# Product Change Notification (PCN)

PCN Number	508159	Date Issued	January 17, 2020
Reason for Change	Equipment Transfer, Production Transfer or Rearrangement		
Change Type Description	This letter is to inform you that production of the part(s) identified in this notice is being moved to a different production location. No changes will be made to the product as a result of this move.		
Reason for Short Notice	Special Request		
Assessment of Change	Product will be fully qualified before it is shipped. Qualification reports will be available after below listed date		
Internal Molex Qualification Date	January 17, 2020		
Sample Availability Date (Changed Part)	January 17, 2020		
Planned Implementation Date	February 17, 2020		
Method of Identifying Change	Date code

**Impacted Products Pictures**

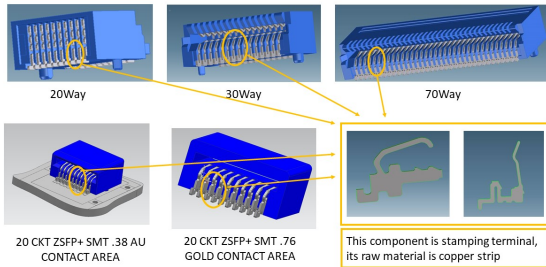
- In order to avoid the potential supply chain risk:
  - Molex Chengdu will qualify the second source of copper strip .
  - Molex Chengdu will add local qualified vender as stamping source, then able to run terminal production in both locations Molex Chengdu & local qualified stamping vender.
- Product Impact: No impact to fit, form or function
- Part Number Impact: see attached impacted parts list
- Qualification reports and samples available upon request
